BOA Architecture / Government Services
Rancho Palos Verdes ADA Assessment

Facility Report with Photos - Programs Services

Facility ID: # 02B - City Hall Buildings

Keynote 4

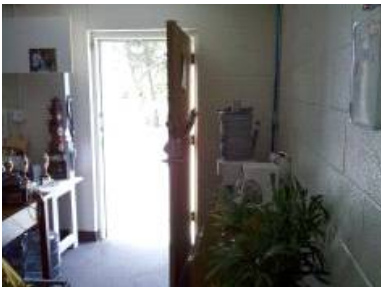
414 - Exit Sign - Ground Floor - At ground floor door which exits to exterior, provide a tactile and CA Braille exit sign with the word "EXIT" mounted on the wall adjacent to the latch side of the door.

Keynote 158

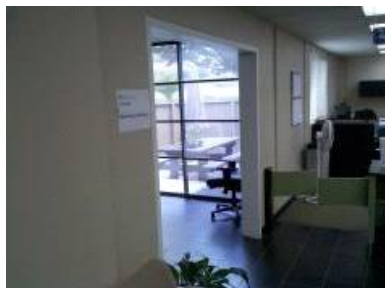
411 - Room Identification Sign - Remove old room signage, if applicable, and provide a new room identification sign with contrasting raised lettering and California Grade II Braille. Install sign 60" above finish floor to center of signage on wall adjacent to latch side of door (right wa
